February 19, 2019

Heritage Permit Application HP2018-046, Under Part V of the Ontario Heritage Act, for the erection of a single detached dwelling at 47 Markland Street, Hamilton (PED19035) (Ward 2)

Venetian-style window located above the side entrance on the west elevation of 45 Markland Street. Left: Inside view, Right: Outside view

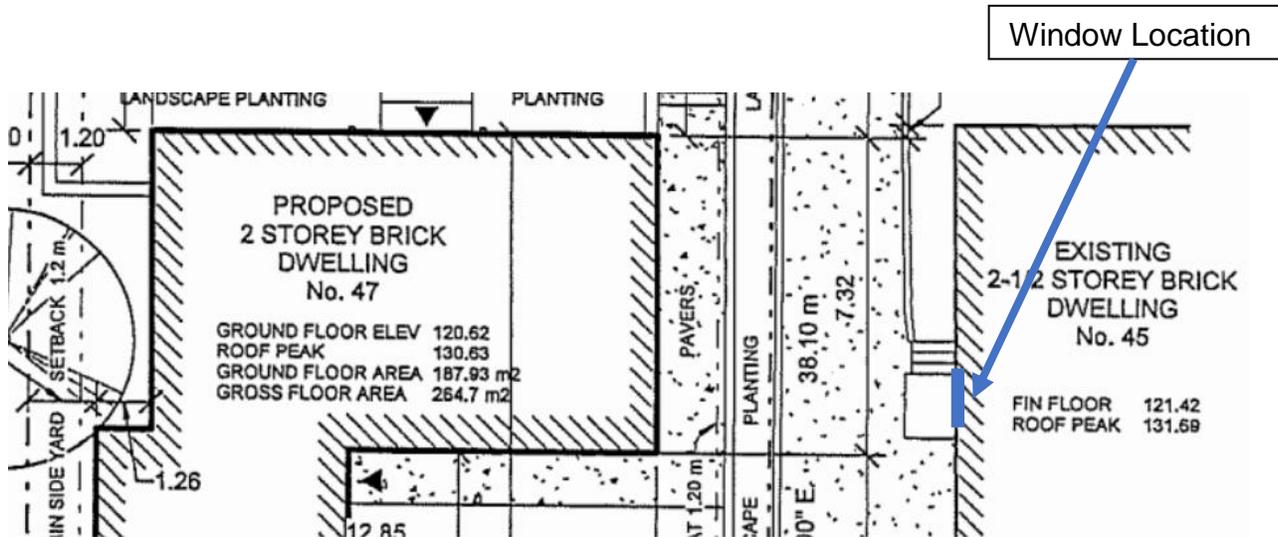
Siting and design of the proposed two storey portion of the structure blocks the western centre hall window at 45 Markland Street. This is a major (5.5 ft. x 7 ft.) westerly facing window providing important light to the upper and lower floors of 45 Markland street.

Further, the Durand-Markland Heritage Conservation District Study: Heritage Assessment Report specifically highlights the window in its assessment of 45 Markland Street describing it as the, “Venetian-style window located above the side entrance on the west elevation.”

This window is a primary and significant feature of the entire western elevation of 45 Markland, is of cultural heritage value, and thus its integrity should be accommodated in design and siting of a new adjacent infill.

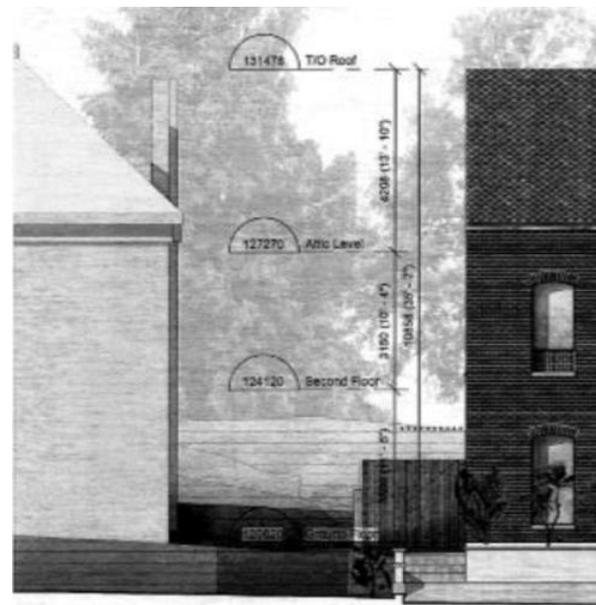
The current design has the two-storey portion of the proposed dwelling aligned as to block the full width of the window (see below). Additionally, the siting effectively minimizes the potential width between the two structures which impacts views and natural light to the major centre hall window of 45 Markland Street.

The eastern elevation of the proposed structure shows a roof design that extends vertically to the tallest peak (side gable), and does not slant like the north and south elevations (hip roof), similar to most neighbouring structures on the street, including 45 Markland Street. The major centre hall window on the western elevation of 45 Markland Street is the primary design feature and is of cultural heritage value. The current siting and design directly impact this cultural heritage feature of 45 Markland Street and therefore, siting of the structure and design of the roof should take specific steps to accommodate this.

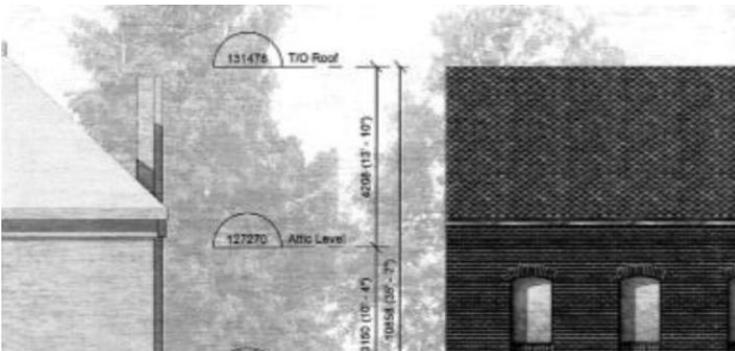
If a roof design was incorporated that was similar to adjacent houses whereby the east and west elevations slant away from their neighbours instead of extending vertically to the peak, the impacts on the western elevation of 45 Markland Street would be lessened (see illustrations below).

- a. *An assessment be conducted on the impact of the proposed design of 47 Markland Street on the Venetian-style window located above the side entrance on the west elevation of 45 Markland Street (e.g. sun-shadow impact analysis).*
- b. *That staff report back on measures that could lessen the impact (e.g. roof design).*
- c. *That final design of 47 Markland Street be approved after demonstrating that measures have been taken to lessen the impact, and maintain the integrity, of this important cultural heritage feature.*
